## Product Similarity Declaration

We, TECNO MOBILE LIMITED, hereby declare that we have a product named as Mobile Phone, Model: LF7, FCC ID: 2ADYY-LF7, has two versions, Hardware version: V1.2 and Hardware version: V2.2, the PCB of those two versions has partial minor circuitry of non-transmitter portions was difference, version 2.1 was tested by Shenzhen Accurate Technology Co., Ltd., The differences between the two versions are as follows:

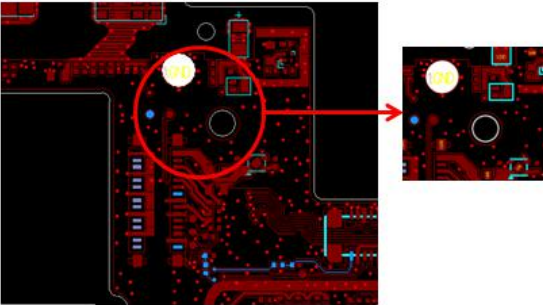
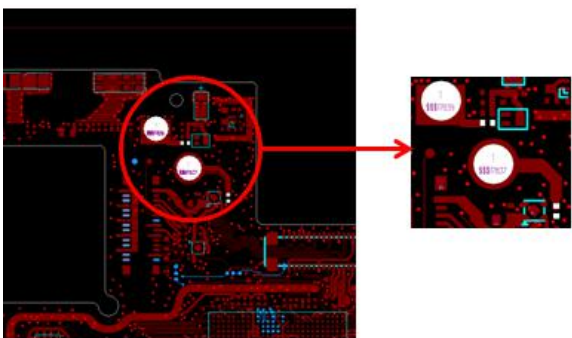
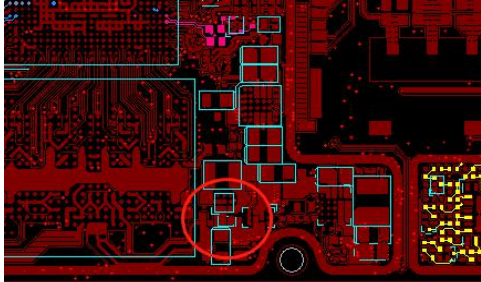
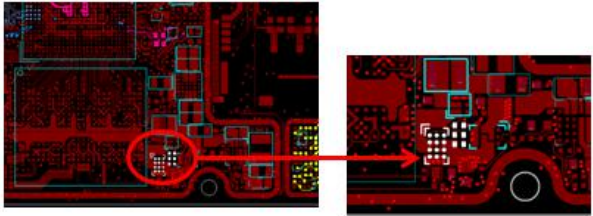
Hardware version	V1.2	V2.2
HOLE1 and HOLE2 are changed to AC grounding		
C2326 changed to 0402 package, withstand voltage 16V capacitor, C2320 changed to 0402 package, 10UF capacitor; Add reverse

charging  
OVPU2307 and  
enable foot  
pull-up resistor  
10K,  
VIO18\_PMU,  
and connect to  
GPIO39

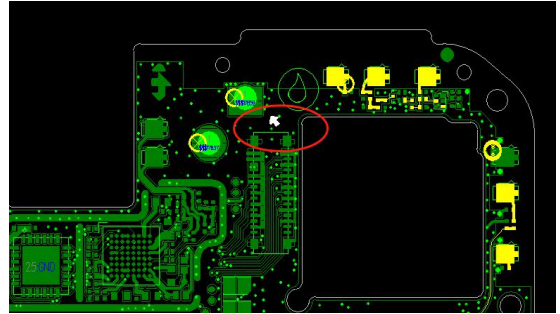
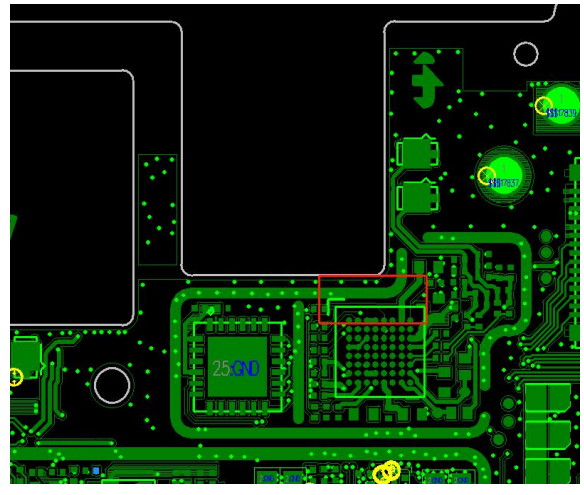
Remove D2302  
Schottky diode

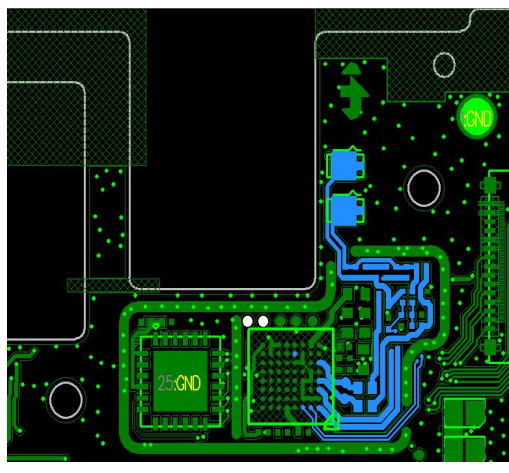
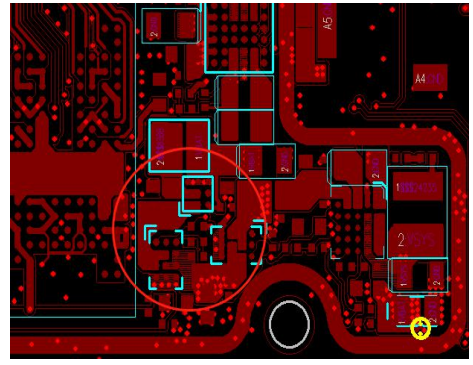
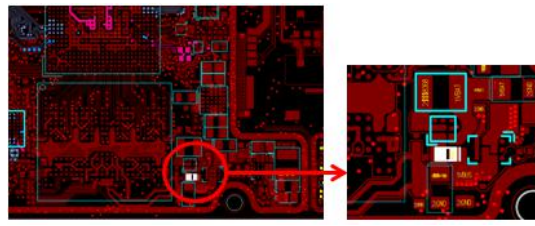
Delete test points  
TP1203 and  
TP1204

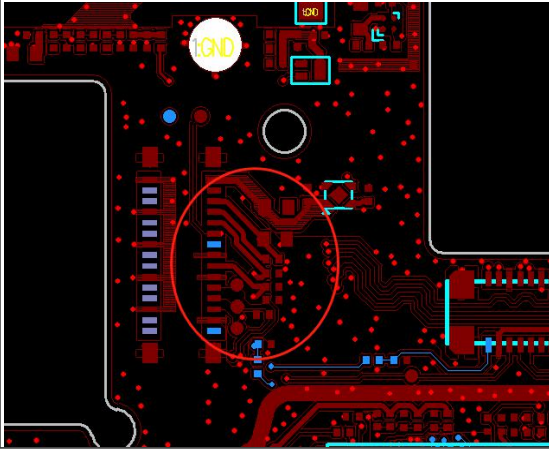
Add lock plate  
screw identifiers  
ARROW1001  
and  
ARROW1002
